Nature of Work: DEMO (E) 246 SF FMLY RM AND CONSTRUCT NEW 336 SF FMLY RM(+90 SF) & REPITCH (E) ROOF STRUCTURE.

RE: McClenahan Residence - 1401 47th Street (Permit No. 0105376)
Response to Corrections Notice - 09/15/01

Field condition approval

CONNECTION OF MULTIPLE PLY BEAMS

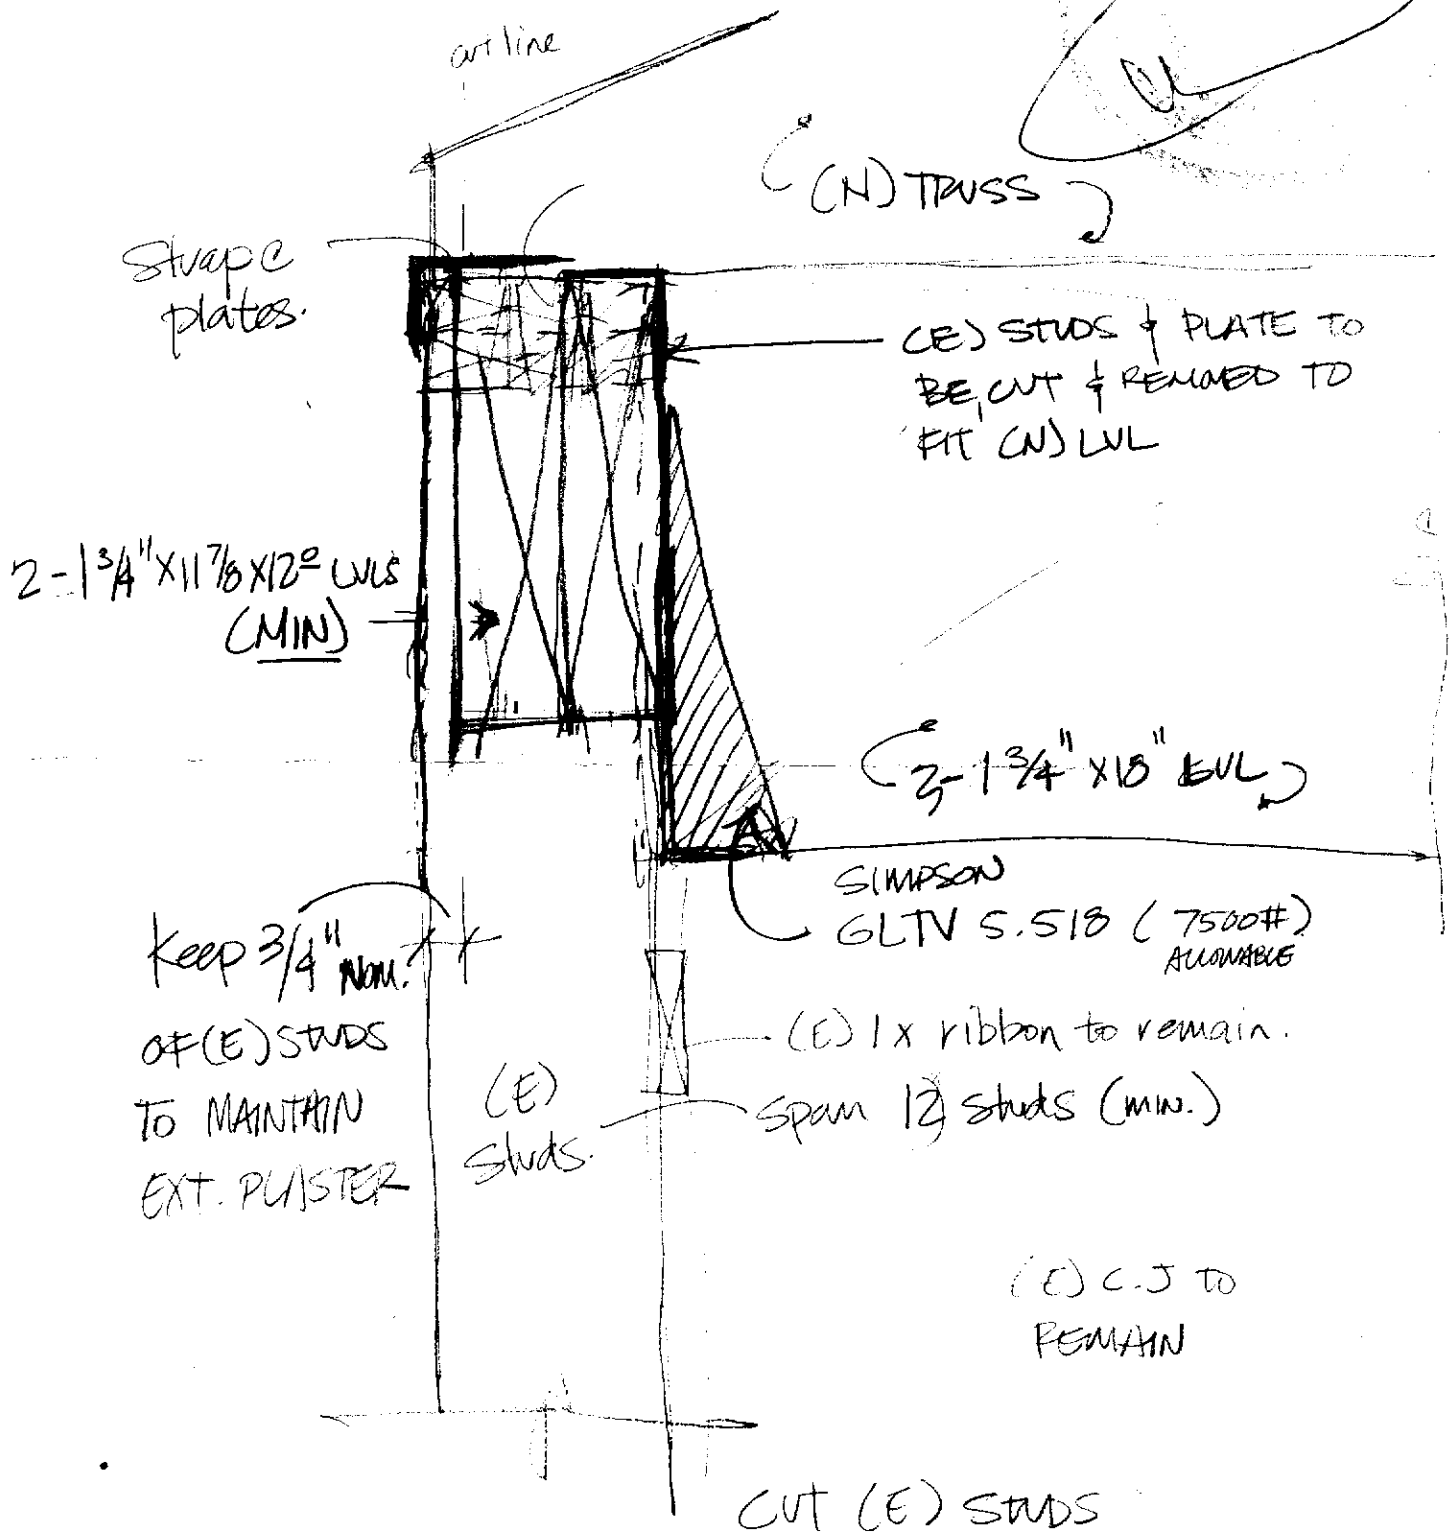
1. The project was designed under the provisions of the 1997 CaBC for Conventional Light Frame Construction (Ch. 23, Div. IV) which allow for 3-8d toenail at blocking between joists or rafters to top plate, (Table 23-II-B-1 Nailing Schedule - enclosed) for the adequate transfer of shear from roof framing to existing and new construction. No detail is required.
2. Anchor bolts will be provided by Contractor at all plate breaks.
3. Enclosed is a detail sheet from the manufacturer of the LVL's that show the nailing schedule for three ply or less LVL's. This should provide adequate information for the requested connection detail of a multiple LVL.

NOTE: (For 3-ply beams) Fasten 2 plies together with nails in each face as shown. Fasten 3rd ply. Load must be applied to face opposite 3rd ply.
